**STAFF REPORT
WEST ALLIS PLAN COMMISSION
Wednesday, February 28, 2024
6:00 PM
West Allis City Hall – Room 128**

2. **Site, Landscaping, and Architectural Design Review for an accessory parking facility, at 9422-30 W. National Ave. submitted by John Fuchs and Nick Fuchs on behalf of Milwaukee Entertainment, LLC (Tax Key No. 479-0674-003).**

5 Landscape Plan View
Scale: 1/4" = 1'-0"

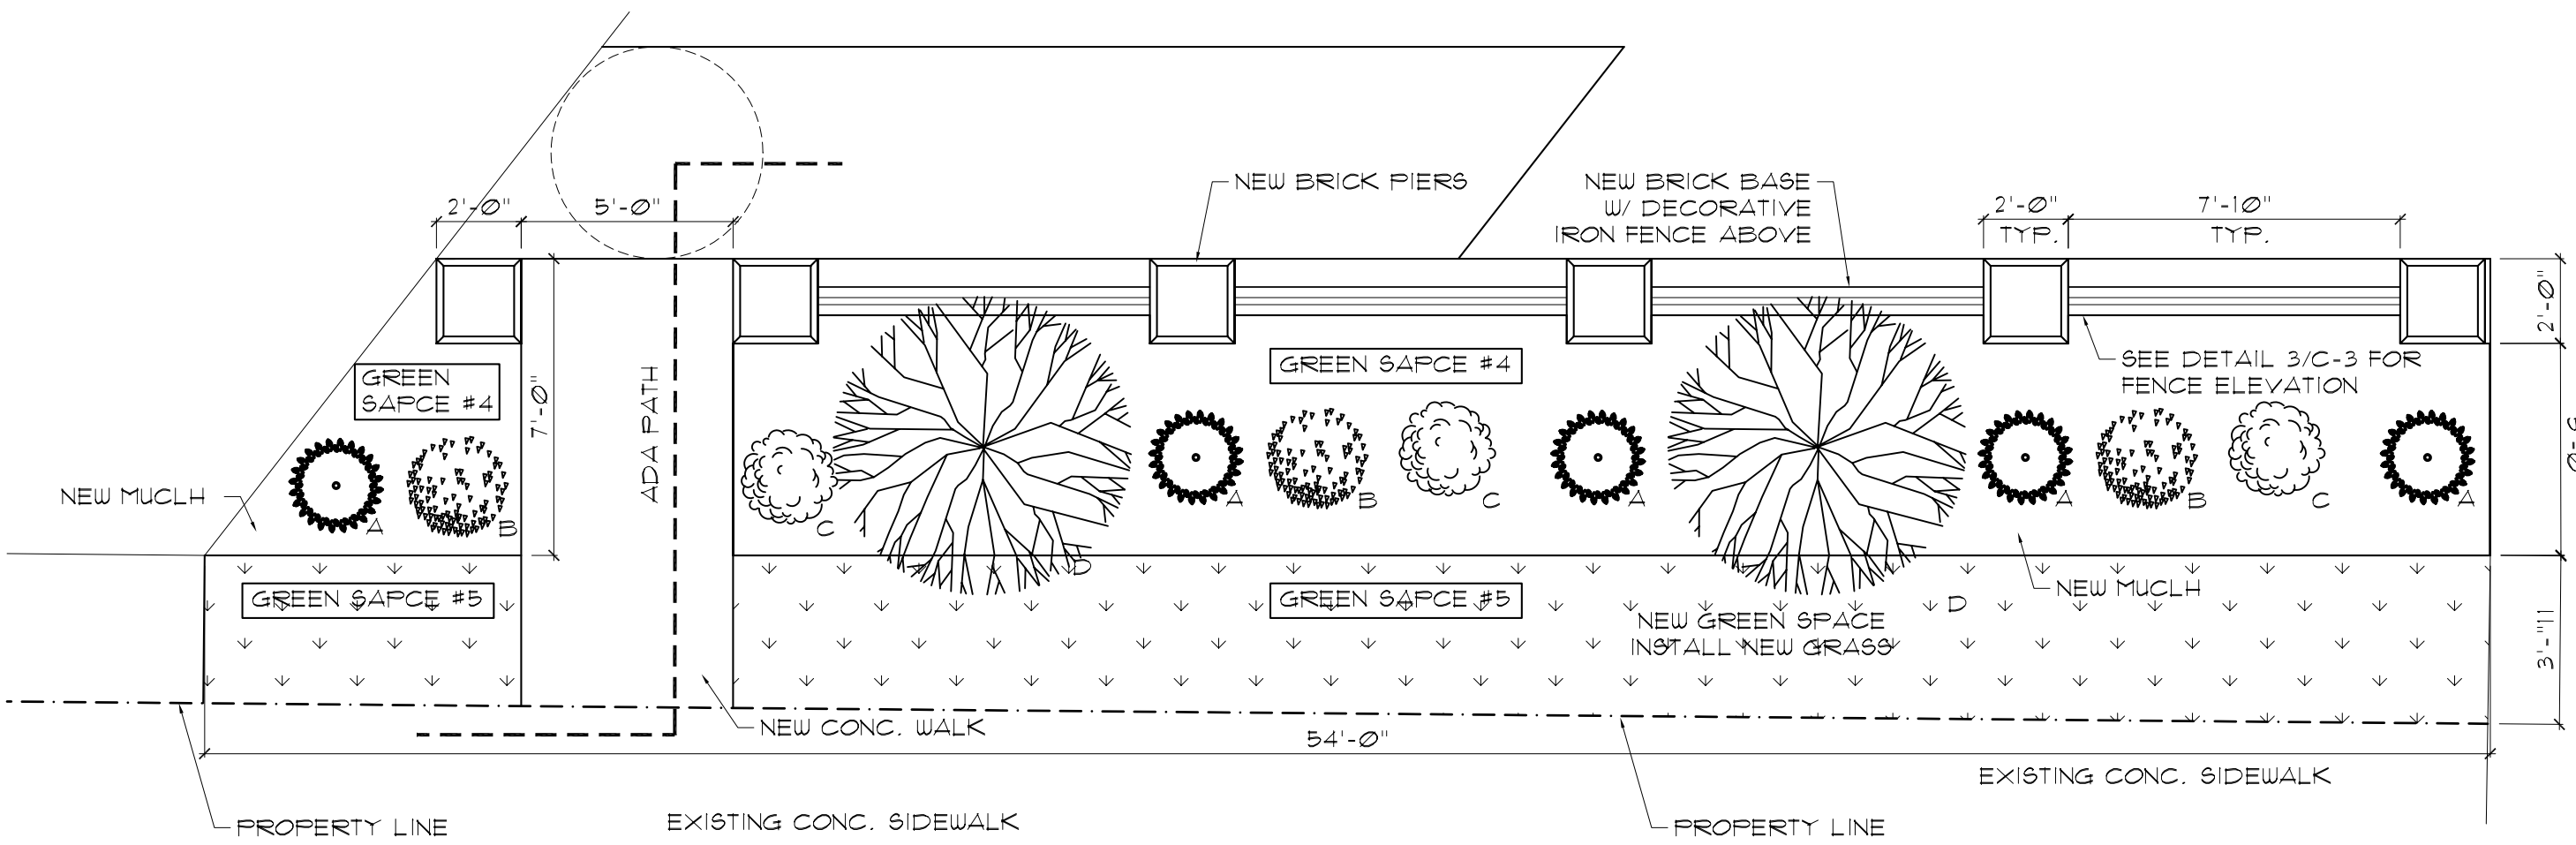
- The retaining wall plans show a drain tile being added on the north side of the wall. Where is it draining (the outlet) shall be shown on the plans. A grading plan is recommended to be submitted as part of the project to understand where the drainage is going. No spot grades are on any plan. Sheet C-3 states there is a detail on C-4 for an existing catch basin, but not seeing it.

8. Documentation and approval showing compliance that existing catch basin on site is designed to accommodate storm water for new parking area.
